## Final Product/Process Change Notification

Document #:FPCN26212X

<b>Title of Change:</b>	Qualification of onsemi ISMF FAB (Malaysia) and ATO site onsemi Leshan (China) for PIN diode housed in X3DFN package.
<b>Proposed First Ship date:</b>	31 Mar 2025 or earlier if approved by customer
<b>Contact Information:</b>	Contact your local onsemi Sales Office
<b>PCN Samples Contact:</b>	Contact your local onsemi Sales Office. Sample requests are to be submitted no later than 30 days from the date of first notification, Initial PCN or Final PCN, for this change. Samples delivery timing will be subject to request date, sample quantity and special customer packing/label requirements.
<b>Additional Reliability Data:</b>	Contact your local onsemi Sales Office
<b>Type of Notification:</b>	This is a Final Product/Process Change Notification (FPCN) sent to customers. FPCNs are issued 90 days prior to implementation of the change. onsemi will consider this change accepted, unless an inquiry is made in writing within 30 days of delivery of this notice. To do so, contact <a href="mailto:PCN.Support@onsemi.com">PCN.Support@onsemi.com</a>

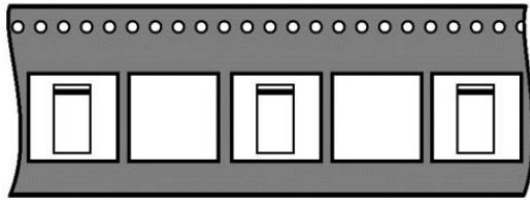
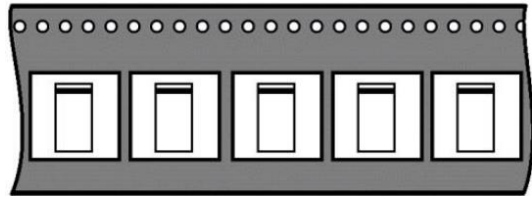
From	To
Product marking change for X3DFN package	 X = Specific Device code M = Date code	 X = Specific Device code M = Date code
